SUPPLEMENTAL INSTRUCTION

PROJ.: **Boys and Girls Club Prince of Wales**
PROJ. No.: **1716**
DATE: **June 14, 2018**
S.I. No. **S.I. - 030**

Correction of Exterior light location and quantities

Electrical Contemplated Change Notice (ECCN)

PROJECT	Boys and Girls Club Renovation Prince of Wales Clubhouse		DATE	24-MAY-18	SCALE	1:100
	DRAWING	ECCN-04 EXTERIOR LIGHTS HOMEWRK CLUB		DRAWN BY	MAG	DESIGNED BY
			JOB NO.	2017-17	CHECKED BY	MAG
			DRAWING NO.		ESK-4

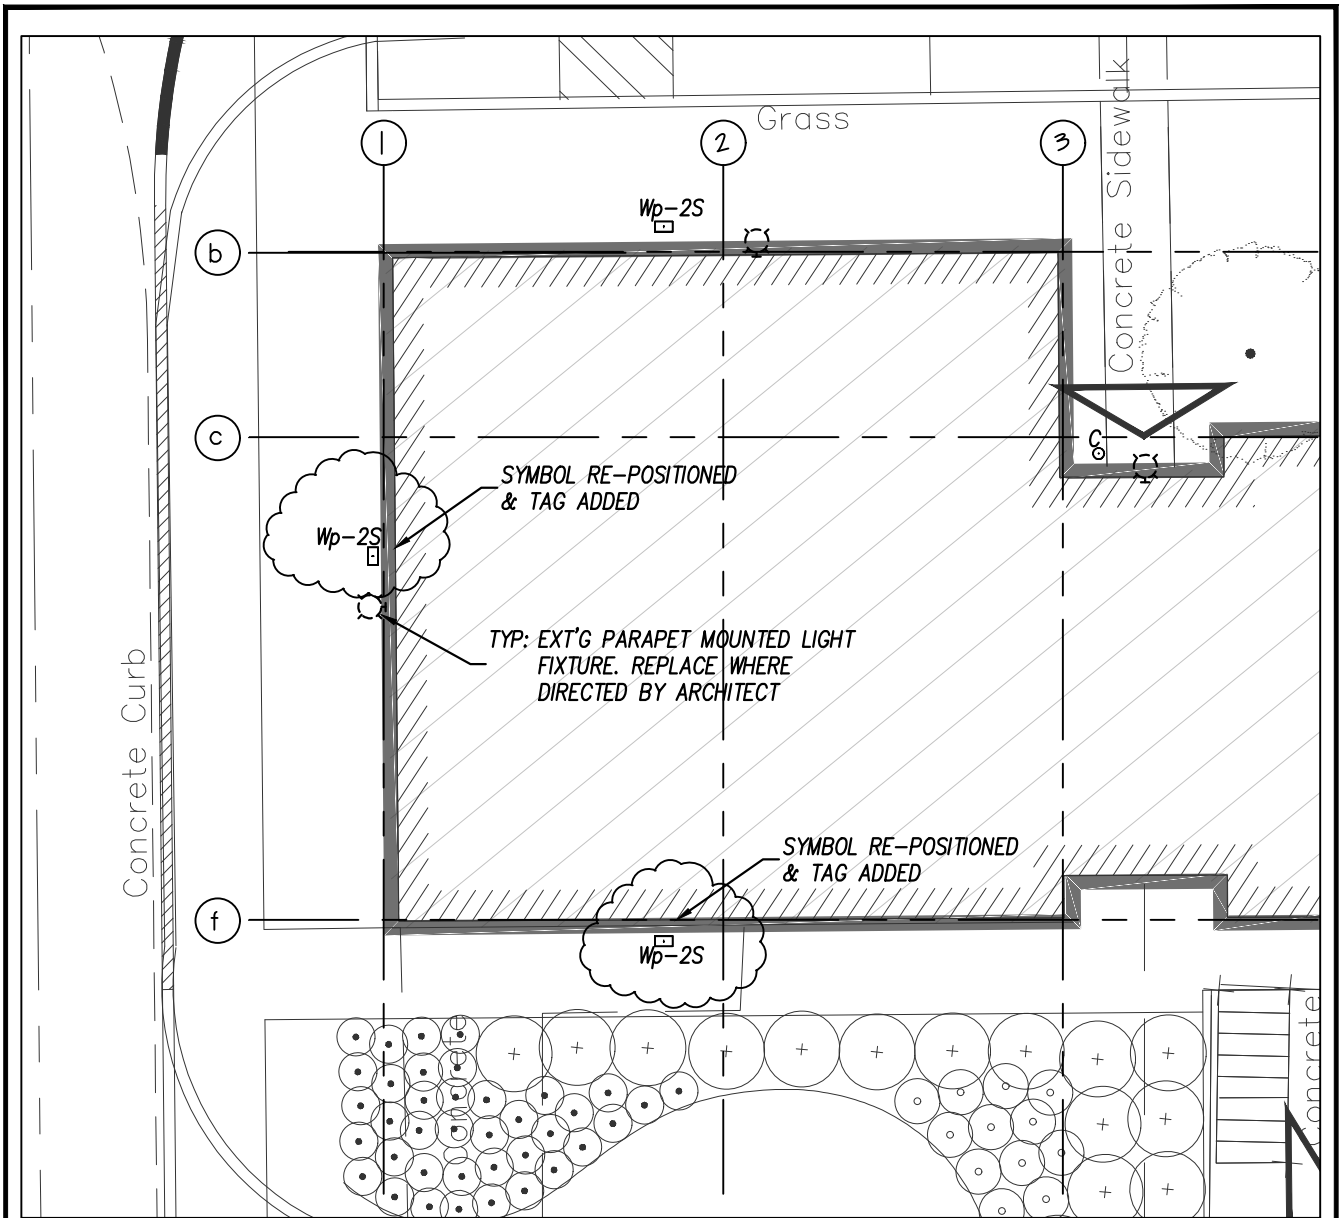
1. See Sketch ESK-4
 - a. 2 exterior light fixture symbols for Wp-2S fixtures were placed on the building outline and not tagged on prior issued drawings. Fixtures are located on the west and south walls of the homework club. Connect fixtures to same circuit as closest Wp-2S fixture located on the north wall of the homework club.
 - b. See Luminaire Schedule E-8. Quantity count of 7 for Luminaire Wp-2S is correct.
